Access Compliance Report Public Rights-of-Way (Pedestrian Signals)

Main Street: STREET_OF_THE_GOLDEN_LANTERN Cross Street: DANA_POINT_HARBOR_DR Location: SE

ADA ID: SGRK220208163651 Signal Type: One Push Button-Non APS Overall Compliance: No Severity Scores: BTN 1: 10 BTN 2: N/A No BTN: N/A

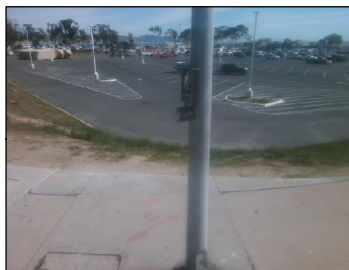
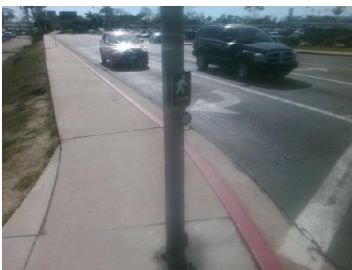
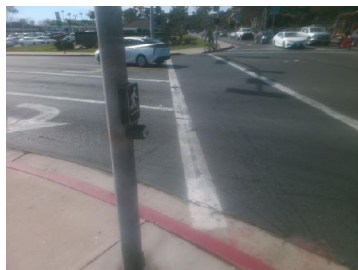
N/A Is Button 1 APS or Non-APS?	NonAPS	N/A Is Button 2 APS or Non-APS?	N/A
N/A B 1 VibroTact Arrow?	N/A	N/A B 2 VibroTact Arrow?	N/A
N/A B 1 VibroTact Parallel to Xing?	N/A	N/A B 2 VibroTact Parallel to Xing?	N/A
N/A B 1 VibroTact Contrast	N/A	N/A B 2 VibroTact Contrast	N/A
No B 1 Pilot Light?	No	N/A B 2 Pilot Light?	N/A
N/A B 1 Pilot Light Illumination?	N/A	N/A B 2 Pilot Light Illumination?	N/A
N/A B 1 Walk Indicator Type	N/A	N/A B 2 Walk Indicator Type	N/A
N/A B 1 Walk Indicator Audible?	N/A	N/A B 2 Walk Indicator Audible?	N/A
N/A B 1 Locator Tone?	N/A	N/A B 2 Locator Tone?	N/A
N/A B 1 Tone Audible Range?	N/A	N/A B 2 Tone Audible Range?	N/A
B 1 Addl APS Features?	No	B 2 Addl APS Features?	N/A
B 1 Addl APS Features Notes	N/A	B 2 Addl APS Features Notes	N/A

Possible Solutions: Replace Signal Push Button With APS Button.
